Reliability Services Initiative – Second Straw Proposal Comments

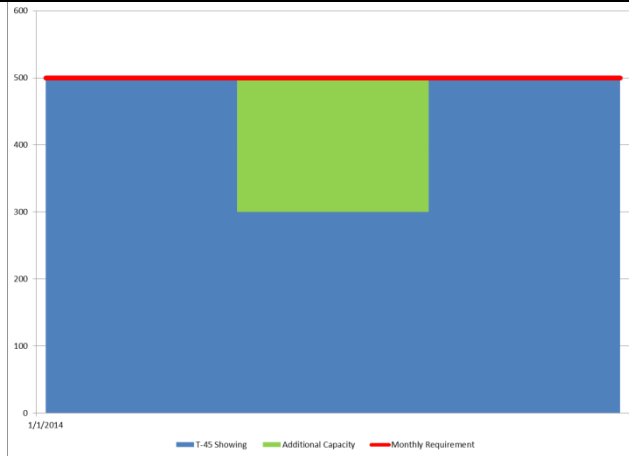
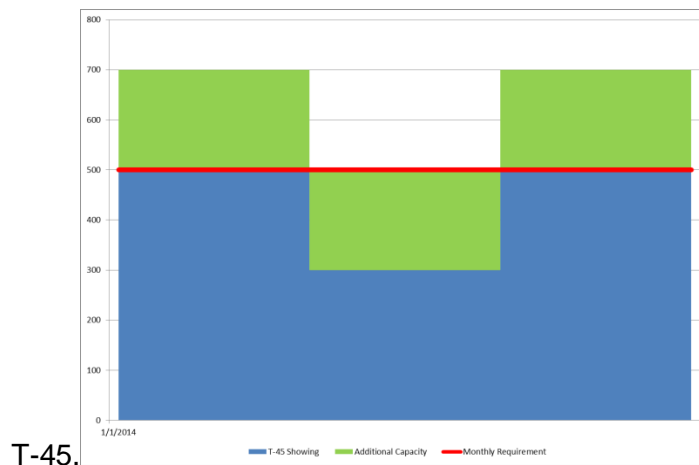
Along the same lines, SDG&E again strongly recommends the ISO to consider a minor change to its current replacement process at T-11. SDG&E believes the ISO should allow LSEs to submit new Designated resources at T-11 in order to meet the PRM. Currently, the ISO only accepts Specified or Non-specified replacement at T-11, the ISO only accepts new Designated resources prior to T-25 in order to cure deficiencies or fix administrative errors.

As an example, at the T-45 showing, the LSE provides 500MWs of capacity which meets 500MWs of RA requirement. Assuming a 200MW outage during the month, the LSE is able to provide 2 solutions.

Option 1: Provide Specified capacity or Intertie Capacity at T-45 to meet the daily requirement.

Option 2: Provide extra Designated capacity from a generation resource for the entire month at

In both cases the RA requirements are met. If the LSE provided only 500MWs of capacity at T-45 with no replacement, the LSE is then prohibited from supplying Intertie-capacity or additional Designated capacity at T-11. SDG&E would recommend the ISO allow LSEs to provide additional intertie capacity or Designated capacity at T-11 as there is no issue to grid reliability since the RA requirements are met. This issue is critical to all LSEs and changing the current process could potentially lower replacement costs and provide greater efficiency.
